UNITED STATES PATENT AND TRADEMARK OFFICE

APPLICATION NO.	FILING DATE	FIRST NAMED INVENTOR	ATTORNEY DOCKET NO.	CONFIRMATION NO.
10/829,560	04/22/2004	William Kenneth House	FORM-0004	6354

Office Action Summary

DETAILED ACTION

Annotated Fig. 6 (U.S. Pat. 1,967,846)

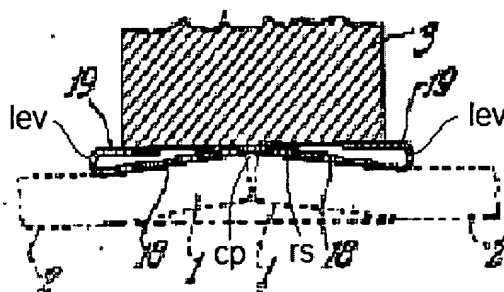
Claim 1 – Utzman discloses a method of making a drywall joint, comprising steps of: (a) positioning a flexible butt block (3, 18, 18, 19, 19) that has a recessed surface (rs) on an interior side of a joint that is to be formed between a first drywall sheet (2) and a second drywall sheet (2), wherein said flexible butt block has a leg portion (18) and a lever point (lev); (b) securing at least one of the first and second drywall sheets to the flexible butt block so that the secured sheet is made to conform in shape to the recessed surface, thereby forming a secondary recess on an exterior of the drywall sheet in the area at which the joint is to be made (note that, although Fig. 6 does not

show nails (6), page 2, lines 48-105 disclose that nails are used in the same manner as in Fig. 4, Figs. 4 and 6 both representing means to positively allow compression on the side of the drywall engaged by the support); and (c) applying joint compound within the secondary recess (Fig. 1, page 1, lines 20-40, and page 2, lines 32-47).

Claim 6 - Utzman discloses the claimed method, wherein said lever point is more flexible than a center portion (cp) of said flexible butt block (the lever point is considered more flexible than the center point because, "flexible" is defined as: able to bend easy (online dictionary, wordnet.princeton.edu/perl/webwn), and the load applied by the bottom of the support (3) to either one side edge (19) or the other side edge (19) during the fastener installation would cause a significant bending load at the lever point by virtue of the relatively high degree of movement of the side edge during such loading as a result of the lack of support offered by the free end of the side edge. Such a bending load at the center point caused by such installation loads being significantly greater than the bending load at the center point by virtue of the center points central location between the two legs and the two side edges, such central location minimizing bending loading at the center point because of the tendency, during installation loading, for the

bottom of the support to apply the load to either one side edge or the other, thus leaving the central point relatively free from the effect of a significant imposed bending load).

Claim 7 - Utzman discloses the claimed method, wherein said lever point is more flexible than a leg portion of said flexible butt block (in light of the above definition of "flexible", said lever point is considered more flexible than a leg portion of said flexible butt block because the unsupported, free end of the side edge would cause a significantly higher bending load to be induced during installation loading of the butt block at the lever point as compared to the essentially non-existent bending load, and therefore flexure or flexibility based on the above definition, that would exist at any location on or in the free-to-move, unrestrained leg portion).

Annotated Fig. 4 (6,807,781)

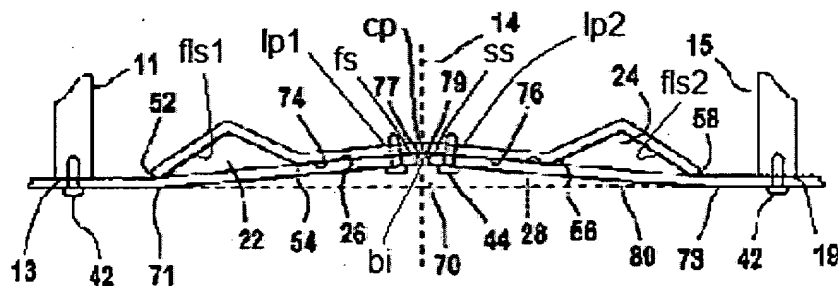
Claim 8 - Trout discloses a flexible butt block (10) for forming a drywall joint, comprising: a first surface (fs, surface between point lp1 and butt end 77) for engaging a first sheet of drywall (71); a second surface (ss, surface between point lp2 and butt end 79) for engaging a second sheet of drywall (73); a first leg portion (raised portion, 52) located at a first distal end of said flexible butt block for engaging the first sheet of drywall; a second leg portion (raised portion, 58) located at a second distal end of said flexible butt block for engaging a second sheet of drywall.

Claim 12 - Trout discloses the claimed flexible butt block, further comprising a first lever point (lp1, point adjacent fastener 44) located between said first surface and said first leg portion and a second lever point (lp2, point adjacent fastener 44) located between said second surface and said second leg portion.

Claim 13 - Trout discloses the claimed flexible butt block, wherein said first and second leg portions have a rounded edge (16, 18, respectively).

Claim 14 - Trout discloses the claimed flexible butt block, wherein said lever point is more flexible than a center portion (cp) of said flexible butt block. The lever point is considered more flexible than the center portion because, "flexible" is defined as: able to bend easy (online dictionary, wordnet.princeton.edu/perl/webwn), and after the Trout butt block is fully installed, the center portion is somewhat restrained from flexing due to the increased rigidity of the butt block/drywall assembly as a result of the fasteners (44) securing the drywall tightly against the first and second surfaces. The lever point, however, is not so restrained. In fact, due to the location of the lever point directly adjacent the fastener, any movement of any portion of the butt block between the rounded edge and the lever point would inevitably cause bending at the lever point.

Claim 15 - Trout discloses the claimed flexible butt block, wherein said lever point is more flexible than a leg portion of said flexible butt block. As described above, the lever point is the point of maximum bending due to its direct proximity to the fastener.

Claim 16 - Trout discloses the claimed flexible butt block, wherein said first and second leg portions have a substantially flat lower surface (fls1 and fls2, respectively).
